PPSSSH-117 - 43 Bay Road, Taren Point

DA22/0632

ASSESSMENT REPORT APPENDICES

Figure A-1 - Contour Plot: Incremental 24-hour PM₁₀

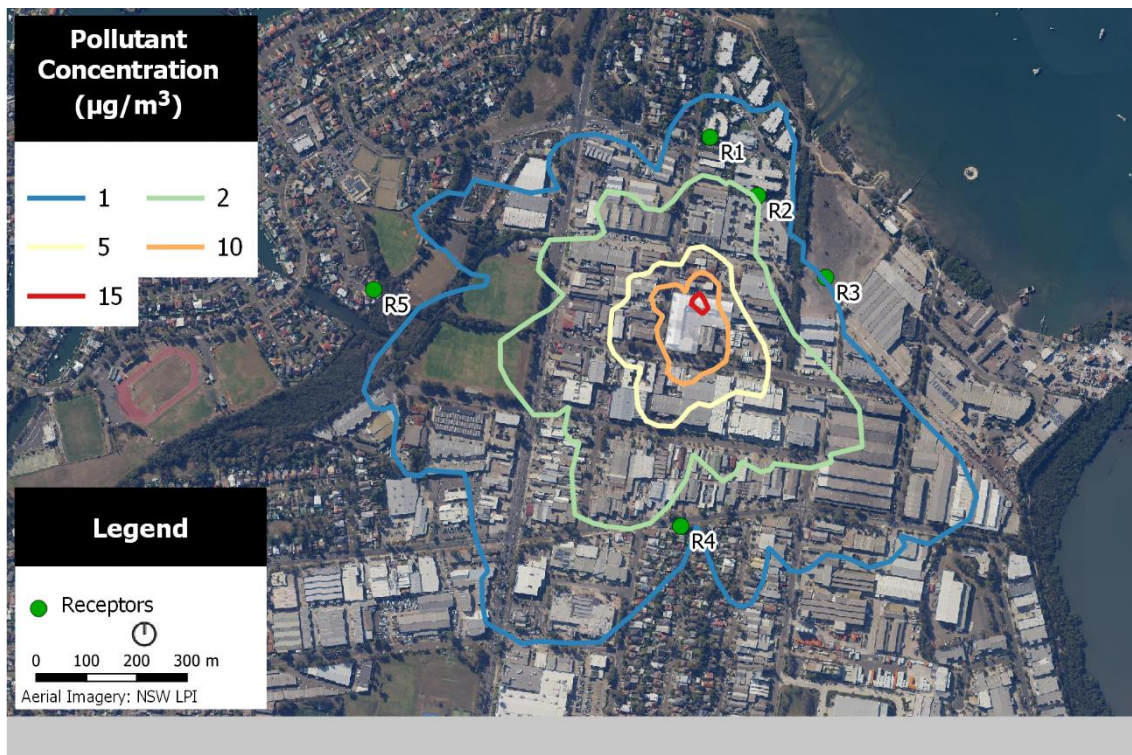
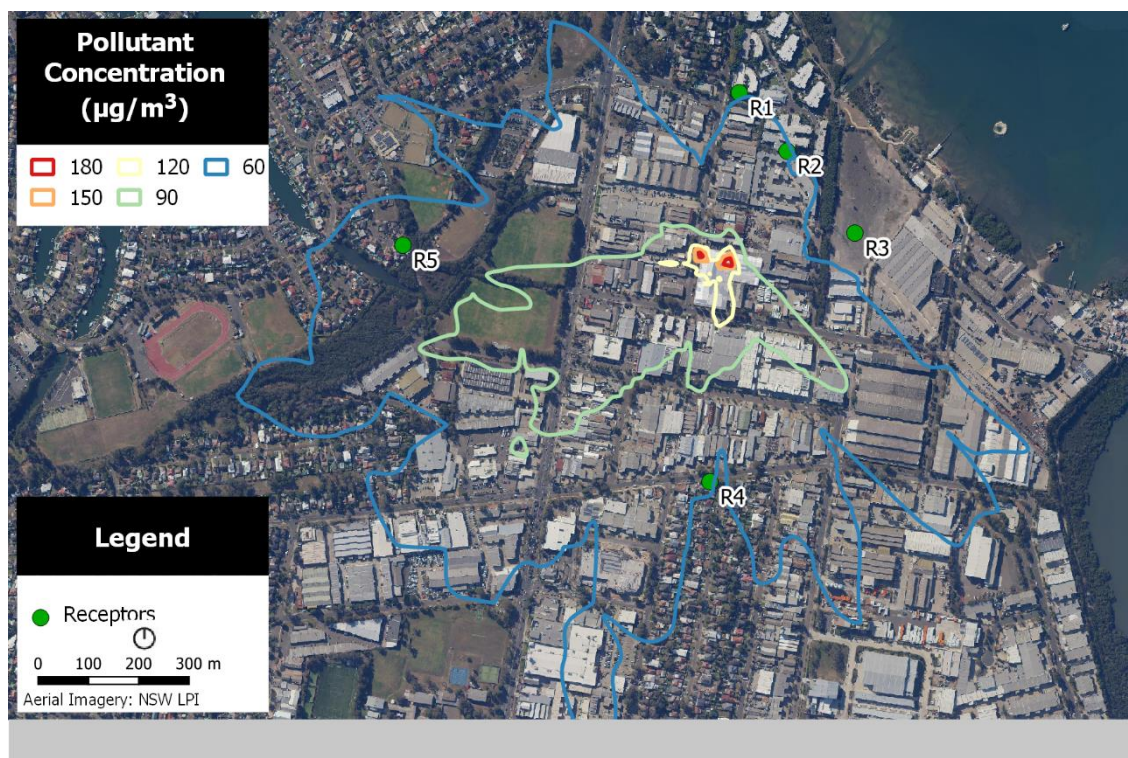
c) *Can the plots indicate the appropriate unit of measurement e.g.: ppm for NO₂. Also is Figure A-1 and A-3 measuring the same pollutant or are they labelled incorrectly? Did they do a contour plot or PM₁₀?*

RWDI (previously known as Wilkinson Murray) advise Figures A-1 and A-3 were labelled incorrectly. RWDI is currently updating their report with the correct contour plots. The updated report will be sent to Council as soon as it is complete.

SHEET TITLE:
Existing Ground Floor Plan

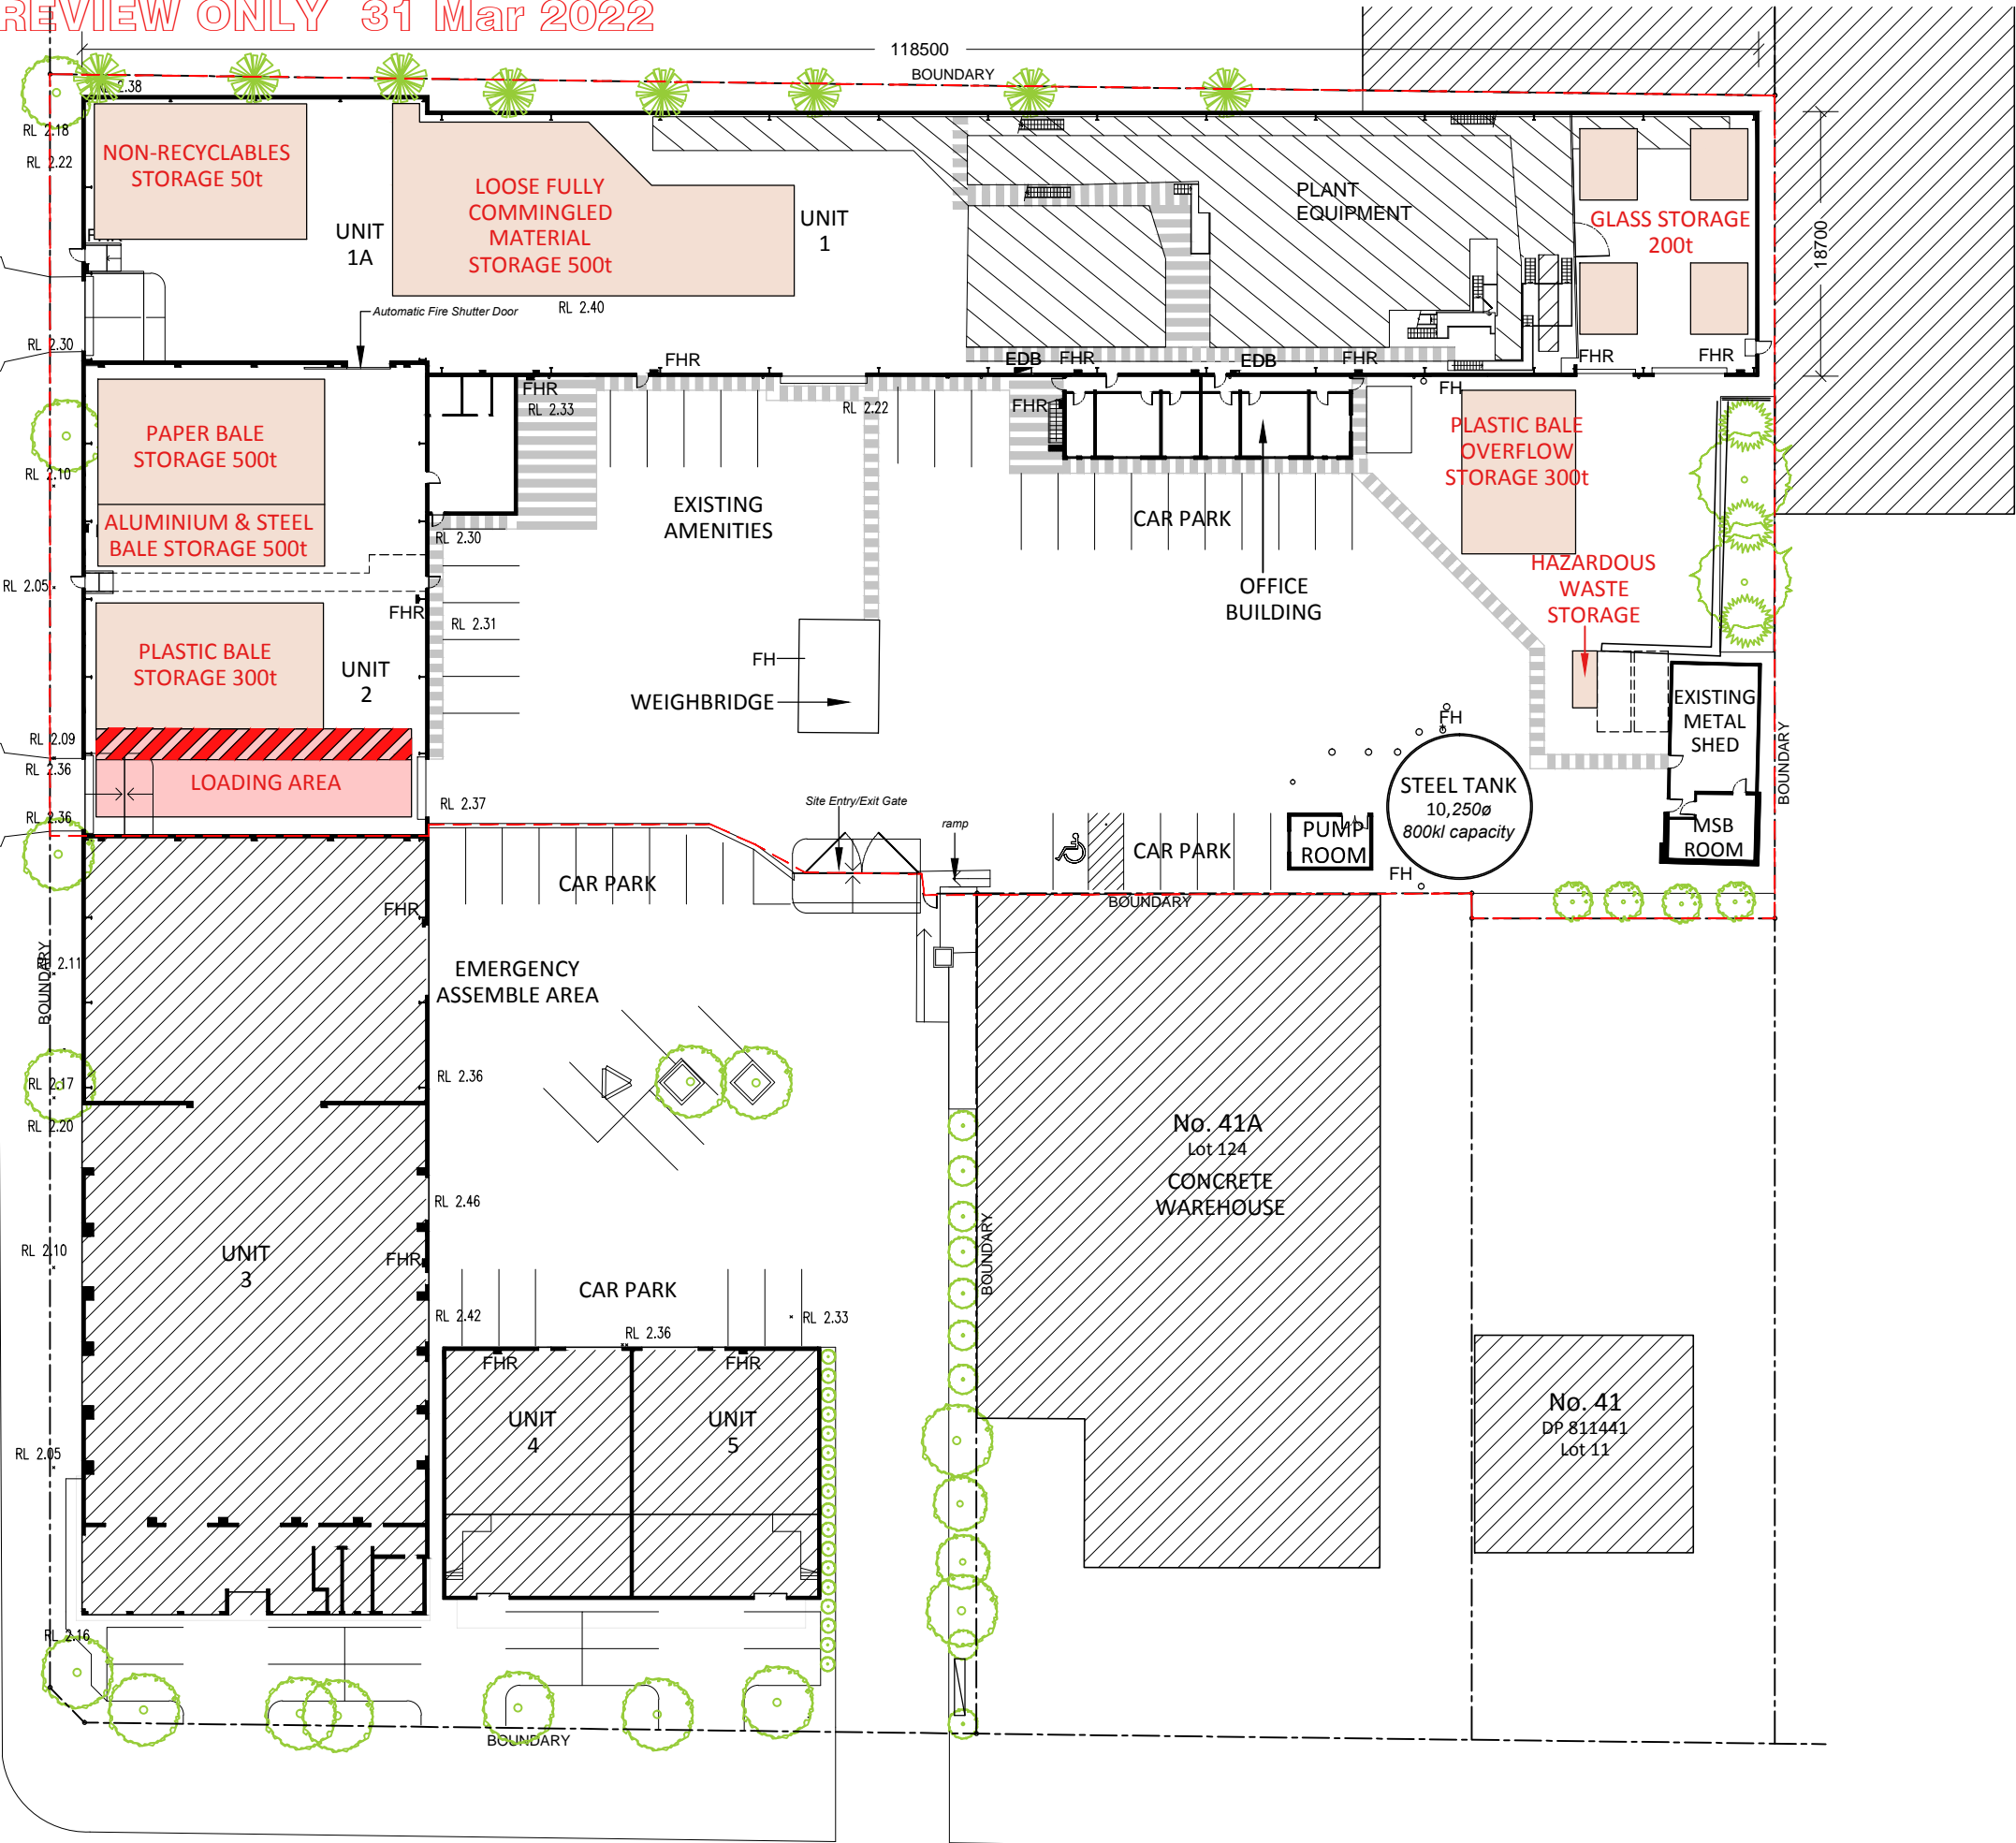
a) *The plan titled 'Existing Ground Floor Plans' Drawing DA02a denotes the shipping containers as being 'temporary'. Page 25 of the EIS describes the 2 containers are being used for storage. Is there a timeframe for their removal from the site and for a permanent structure to be constructed in their place? If so, what is the timeframe for their removal and will plans be submitted in response proposing a new structure? Alternatively, is consent now sought for their permanent retention?*
